AMENDMENT OF SOLICITATION/MODIFICATION OF CONTRACT			1. Contract Number	Page of Pages 1 of 4	
2. Amendment/Modification Number No. 5		3. Effective Date See Block 16C		4. Requisition/Purchase Request No.

Amendment No. 5
Issued July 24, 2008

Title: Construction of Anacostia Initial Line Segment and the Operation and Maintenance Facility, and Reconstruction of Firth Sterling Avenue.

Questions and Answers No.3

Platform Perspective View - From Street
Barry Farm Platform

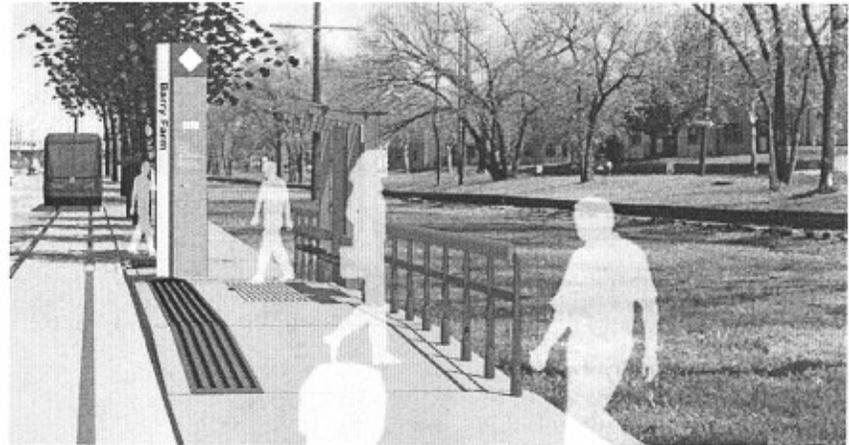
Reference Drawing A8 (Pylon Details)

SKA9 (Streetcar Platform Pylon – Additional Information) is incorporated herein and attached hereto as Attachment 5-6, and shall become a part of the Contract Documents.
